ADDEUNDUM #3
CONTRACT NO: 2024-04E
CHESTNUT STREET OVER IPSWICH RIVER BRIDGE REPLACEMENT
NORTH READING, MA 01864

Edited Sheets 4 &12 (2 pages)
[Clarified access paths to be built “By Others”]
[Identified areas of Wetland Restoration]

RESPONSE TO CONTRACTOR QUESTIONS (Addendum 3) January 16, 2025

TYPICAL SECTIONS & PAVEMENT NOTES

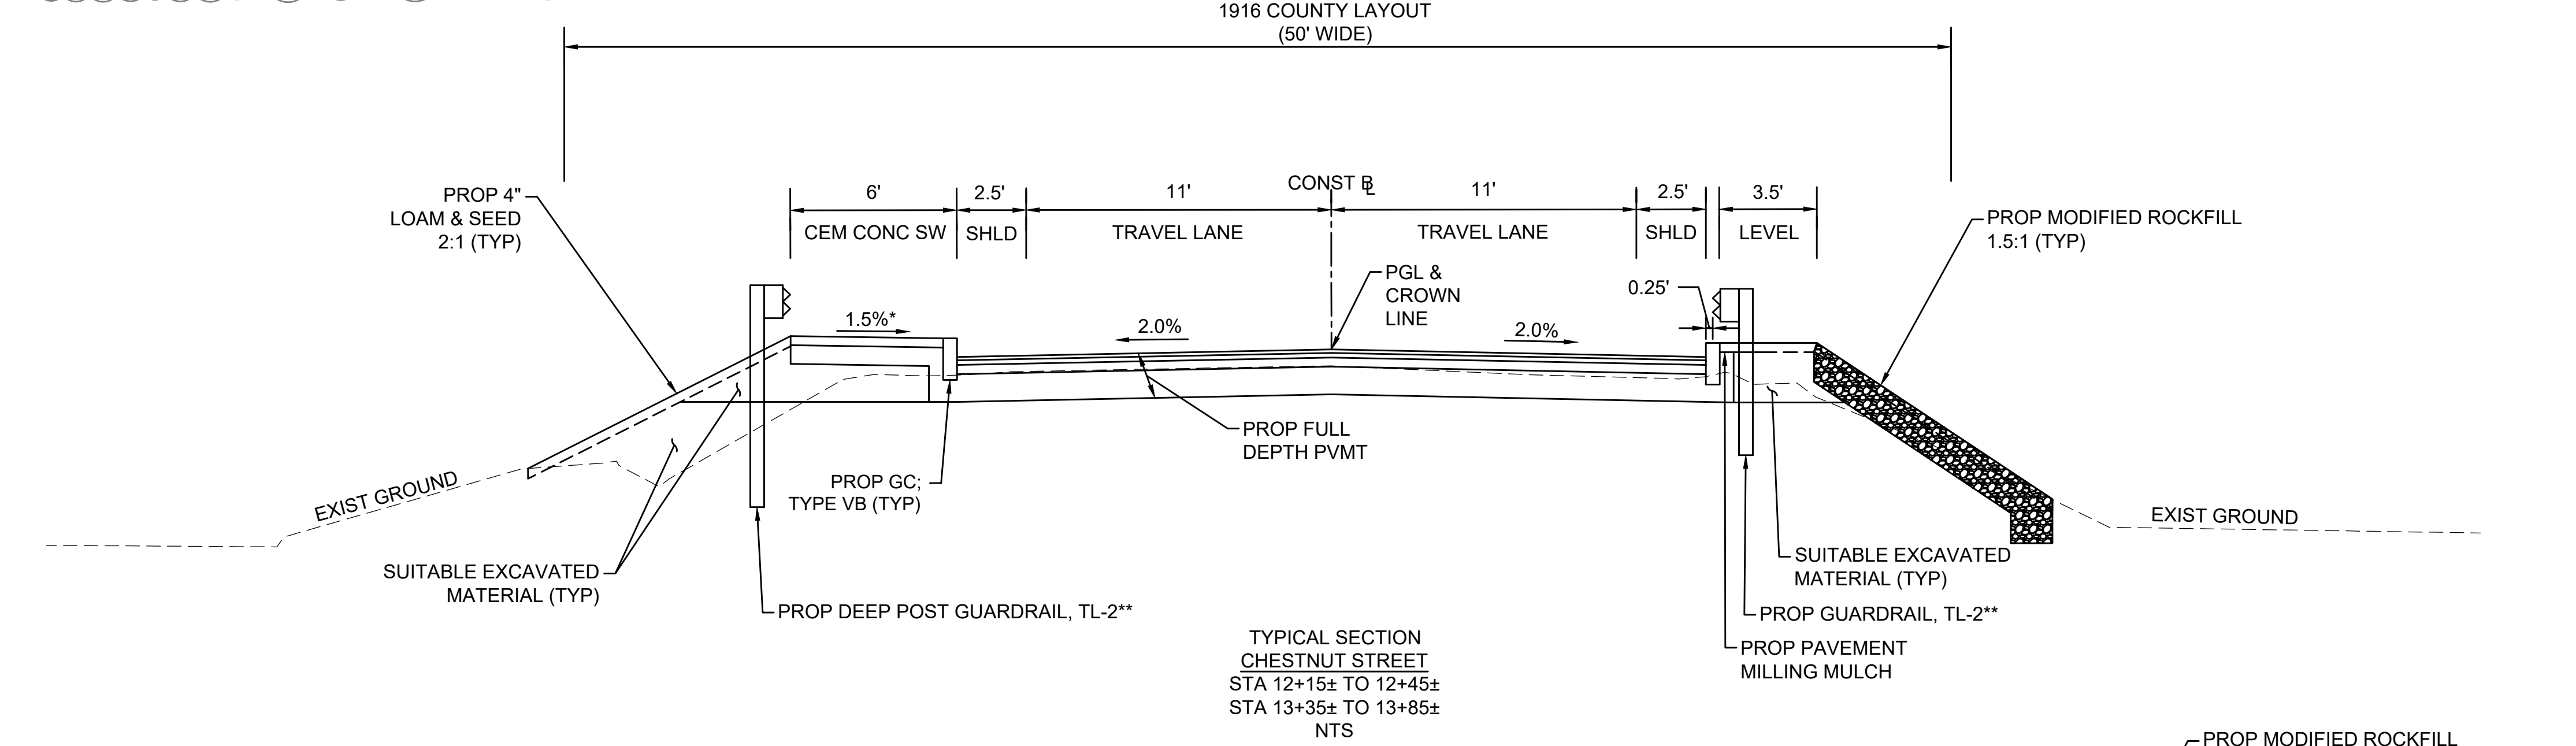
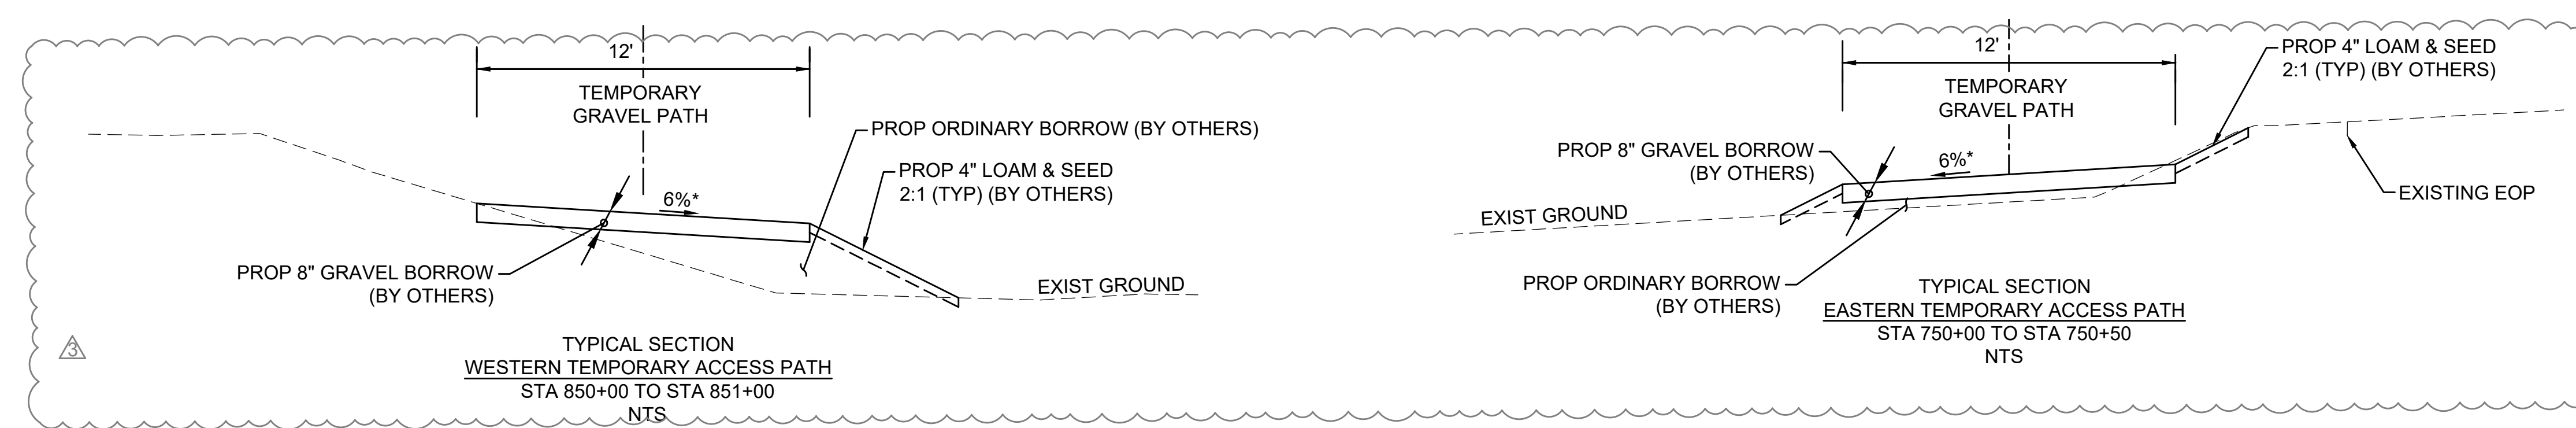
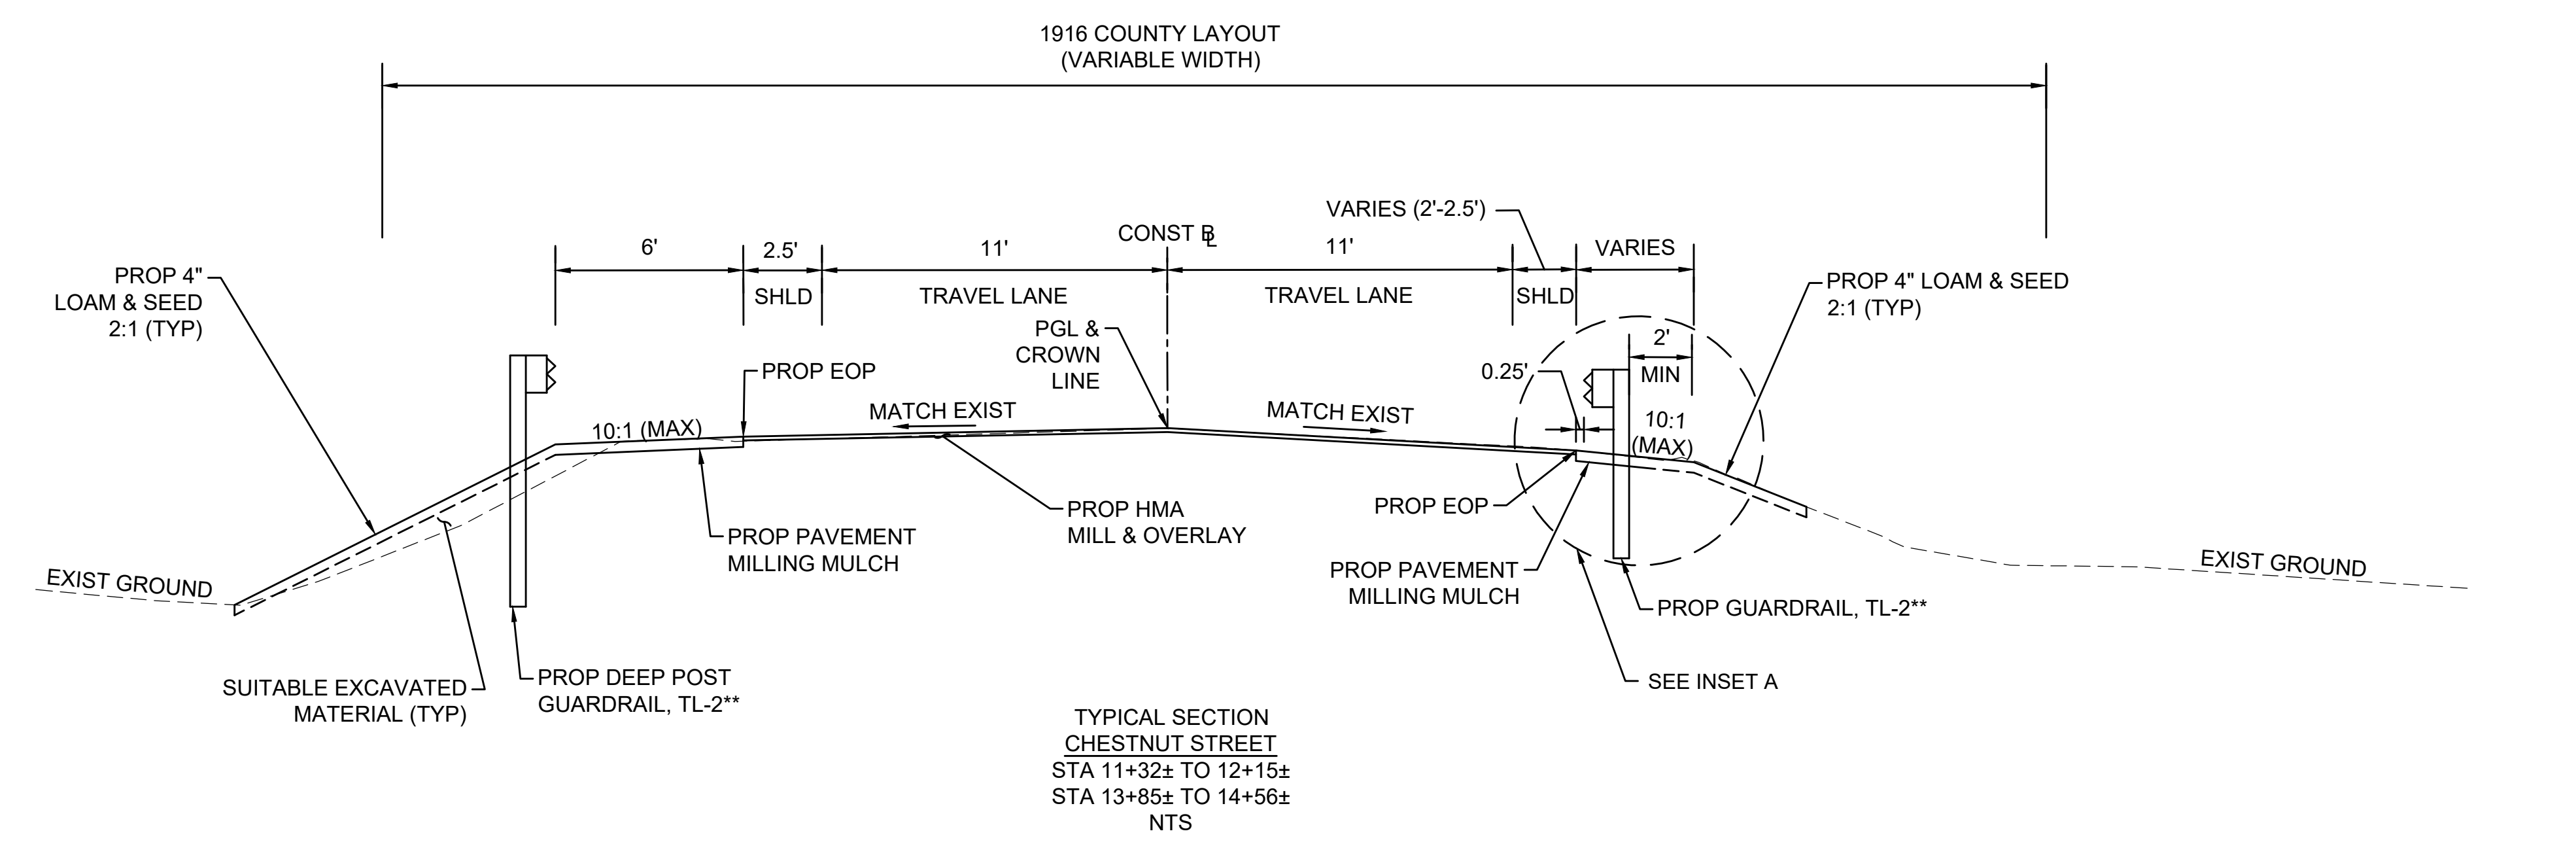
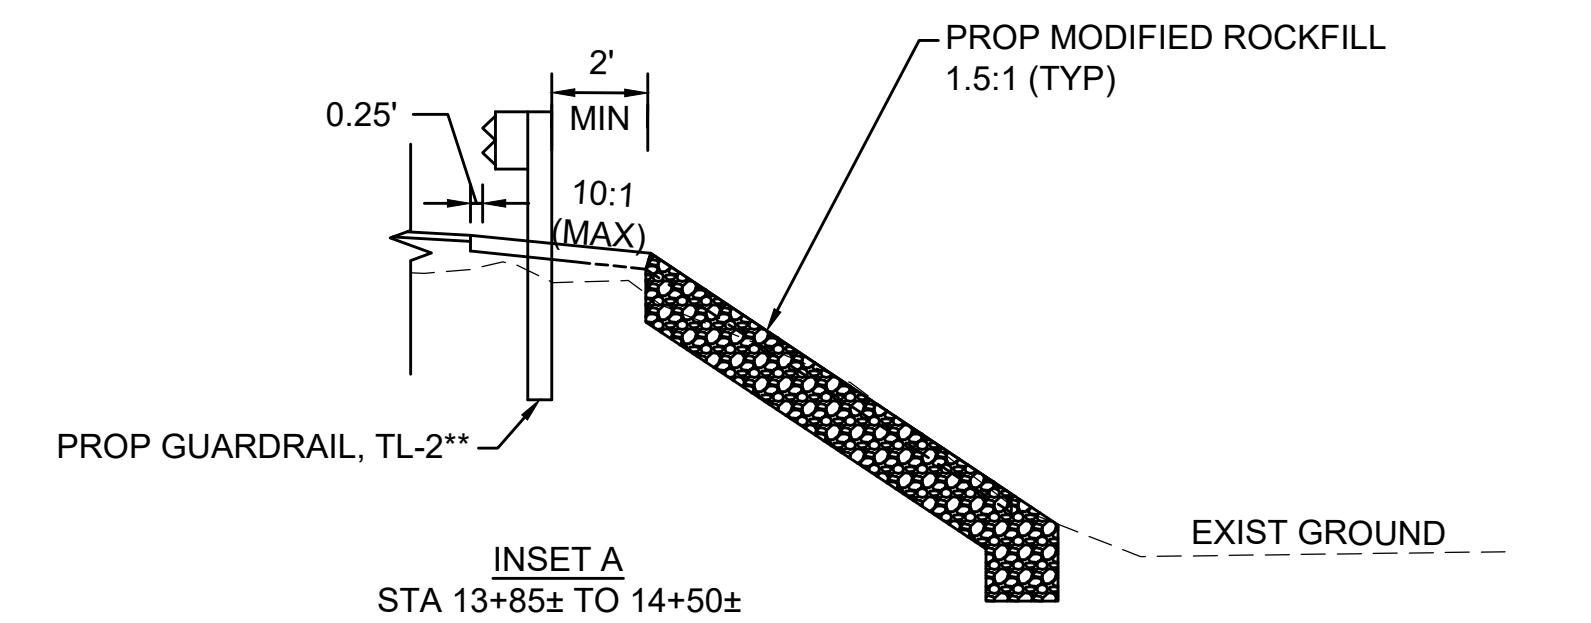
11. The Construction Plans show a 12' Temp Gravel Access Path on either side of the bridge; what pay item covers the cost, installation and removal, of this temporary access path?

A: The temporary gravel access paths will be constructed by the Town, prior to the General Contractor's mobilization. The plans have been amended to label this work as "By Others", refer to amended Typical Sections within. Once the temporary access paths are no longer required, the Contractor shall repurpose this material on site, if feasible, or it shall be removed and disposed of, per Item 120. Upon completion, the temporarily disturbed areas shall be restored to match the existing conditions, the bid tabs have been amended to include Item 755.45 – Wetland Restoration. Refer to the cross sections for the proposed finish grade.

- VARIABLE DEPTH MILLING AS REQUIRED TO MEET PROPOSED LINES AND GRADES WITH RESURFACING OVERLAY.
 - THE PROPOSED TEMPORARY GRAVEL PATHS SHALL BE CONSTRUCTED BY THE TOWN OF NORTH READING DPW IN CONJUNCTION WITH THE PROPOSED UTILITY POLE RELOCATIONS, IN ADVANCE OF THE CONTRACTOR'S MOBILIZATION. THE CONTRACTOR IS RESPONSIBLE FOR RESTORING THE TEMPORARILY DISTURBED AREAS TO THE EXISTING CONDITIONS, REFER TO THE AMENDED WETLAND REPLICATION PLANS IDENTIFYING AREAS OF WETLAND RESTORATION. REFER TO THE CROSS SECTIONS FOR THE PROPOSED FINISH GRADE.
